RE: **Perc Cert Comment, Tax Map 28, Parcel 13, Parcel 'A'; A534508**

RE: **Perc Cert Comment, Tax Map 28, Parcel 13, Parcel 'A'; A534508**

RE: **Legend issues on Perc Cert. The Oaks at Bridle Creek Parcel 'A' Tenant House and Clubhouse; A534508**

| DRAWN EDS | THE OAKS AT BRIDLE CREEK AGRICULTURAL LAND PRESERVATION # HO-91-15-E Parcel 'A' - Clubhouse | DRAWING 3 OF 3 |

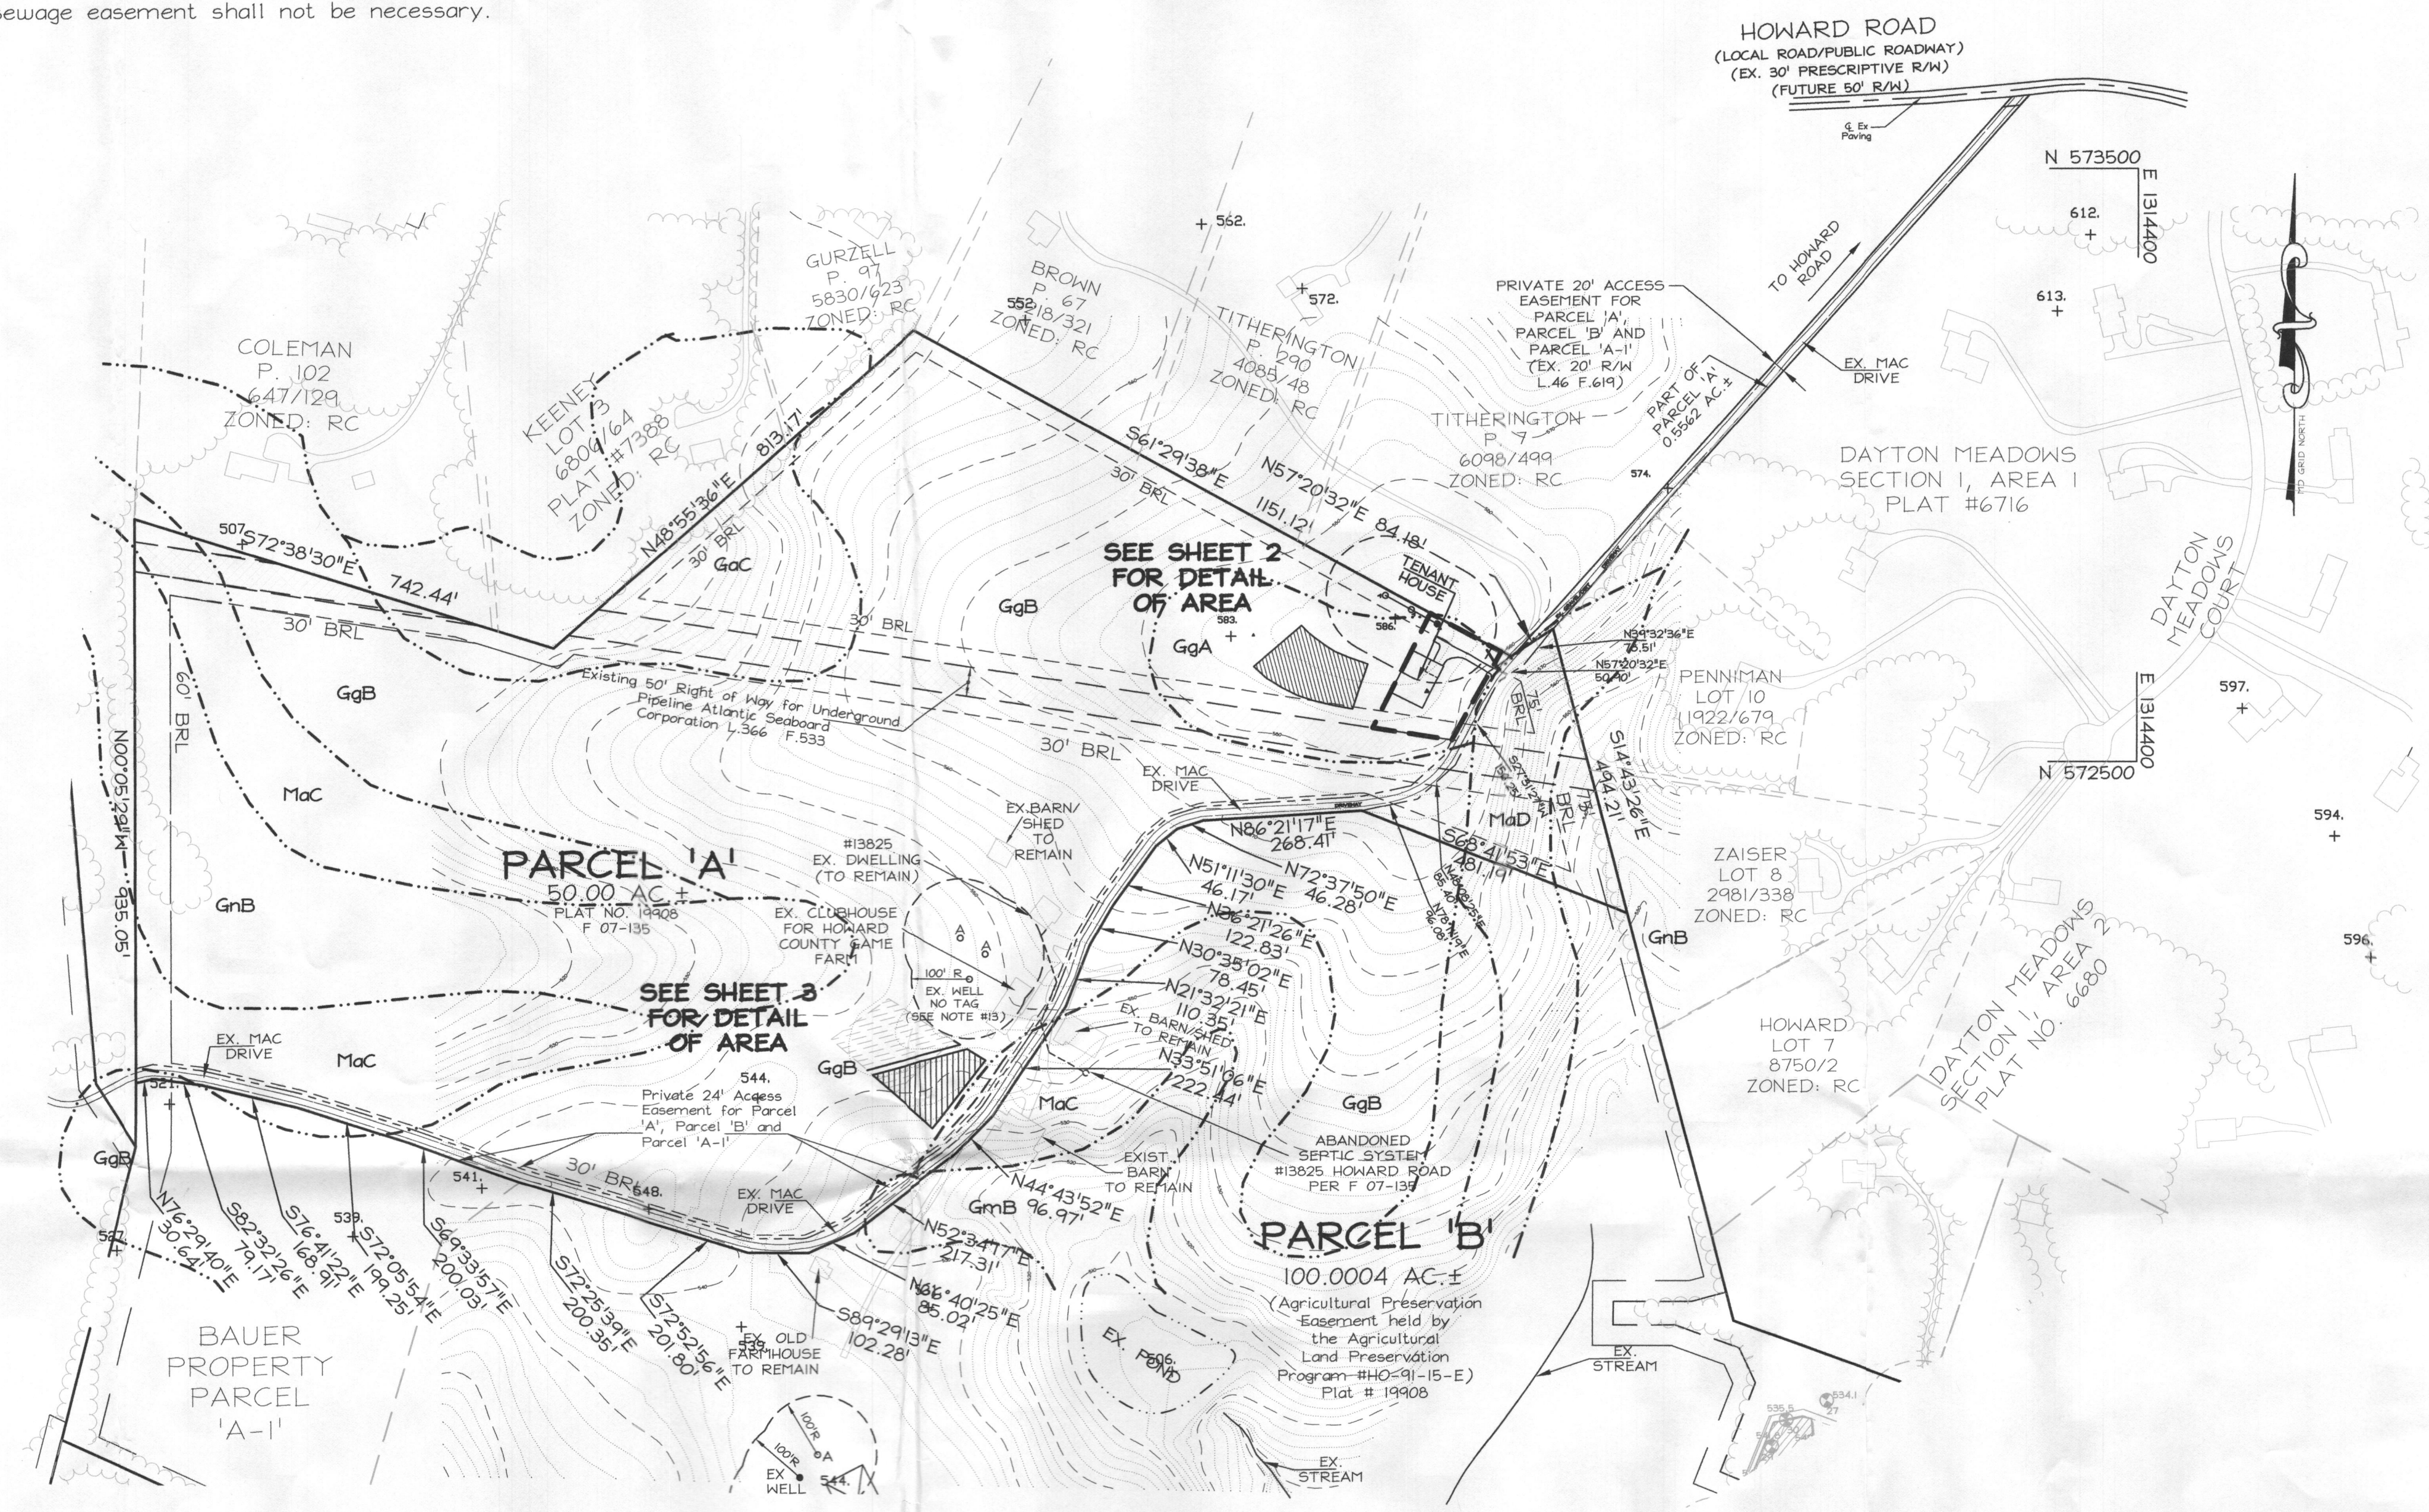
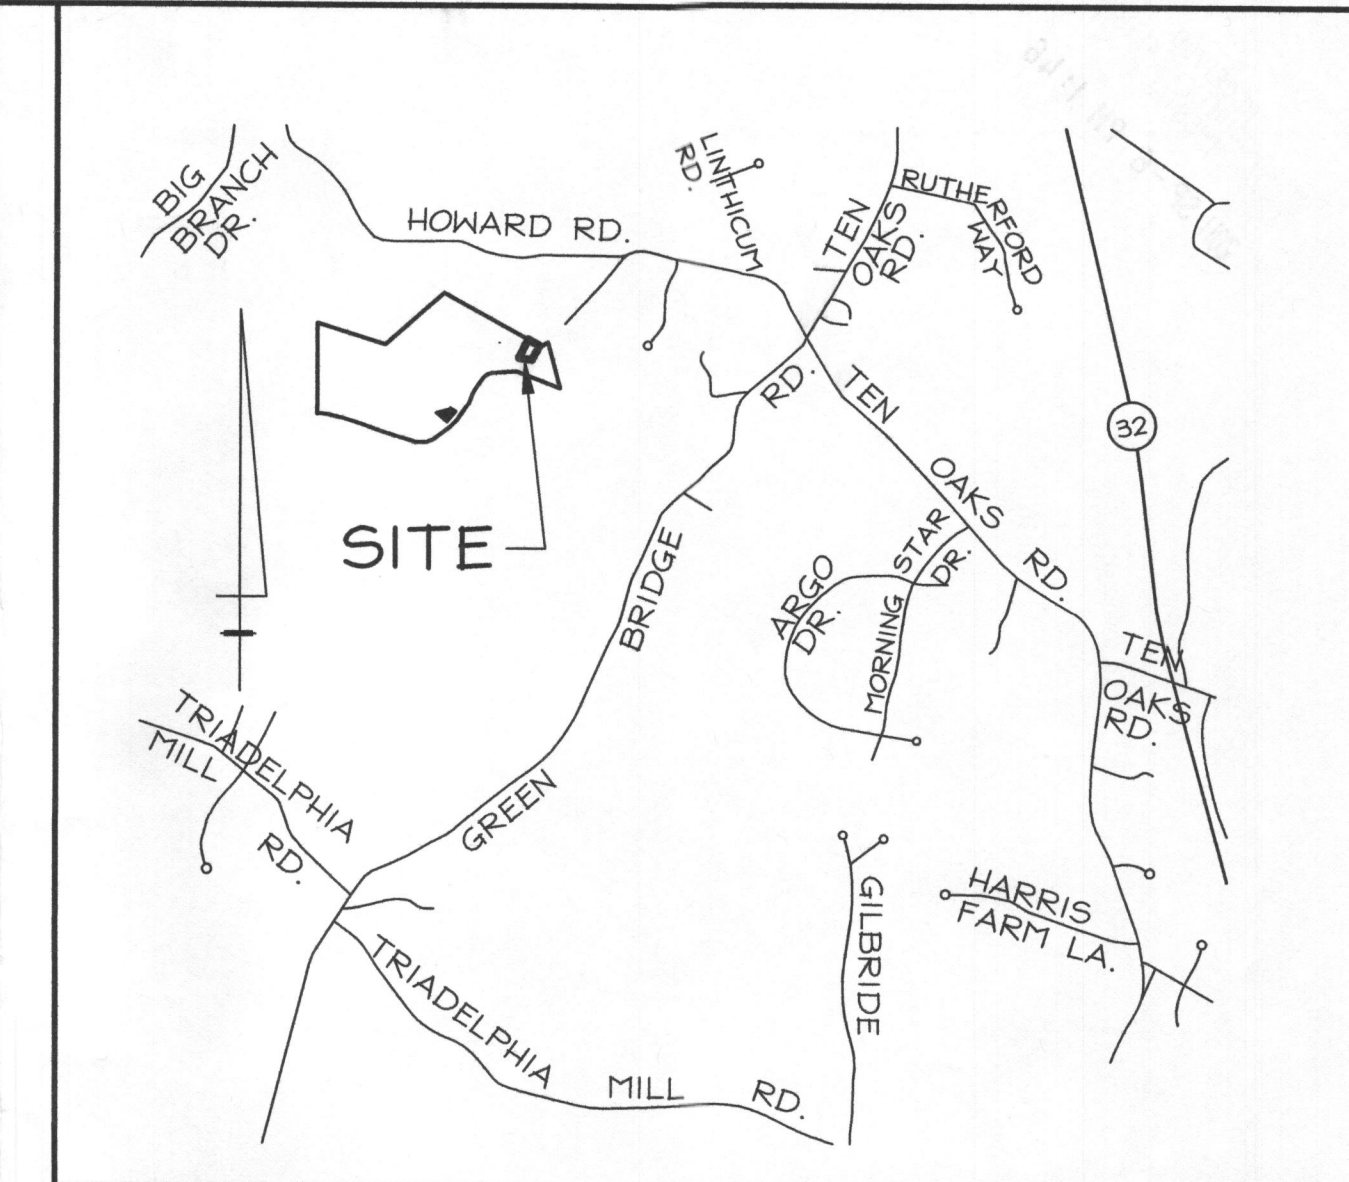
1. On Sheet 1 the existing septic reserve had not been shown with the area to be added for the clubhouse use.
2. On Sheet 1 add a note astating that use of the well is shared among the primary residence and the clubhouse.
3. On Sheet 3 (and on Sheet 1) show a 'buffer' 5 ft- to- 10 ft width, between the septic reserve areas for the primary residence and the clubhouse.

1. Sheet 1, LEGEND:
 - a. Delete entry for 'well box', as there are no well boxes being proposed on Parcel 'A'.
 - b. Correct the symbol for "existing well".

- c. Correct the symbol for "proposed tenant house".
 - d. Correct the symbol for "proposed primary well".
2. Sheet 1, tenant house location on plan: delete "well box" label.

3. Sheet 1, Note 4: suggest more clarity in wording, e.g., wells and septic systems within 100 feet of the proposed project area have been shown.
4. Sheet 1, Note 7: delete.

1. 'Proposed Sewage Disposal easement': a different symbol is used on the plan than in the legend; the symbol in the proposed area on the plan is oriented in a different direction.

2. 'Existing sewage disposal area': Make symbol in legend and on the plan to match accurately. (The symbol in the Legend appears to be dashed lines with periodic solid lines, whereas on the plan the lines are all dashed.)

3. 'Soil Divide': re-title as "Soil Survey Delineation".
4. 25-foot contour
 - a. appears to be presented as a solid line in the legend and as a dashed line on the plan.

- b. confusing, probably unnecessary as the 10-foot contours are presented in conjunction with the required 2-foot contours.
5. "Existing 5' contours": Also confusing as the symbol is very similar to the required 2' contours presented on the plan. Probably not needed.

6. Existing 10' contour, add this as a LEGEND entry with the proper symbol.
7. Existing 2' contour, add this as a LEGEND entry with the proper symbol.
8. 'Existing well': an open circle is shown in the Legend, and on the plan the circle is filled in. Correct entry for accuracy and consistency.
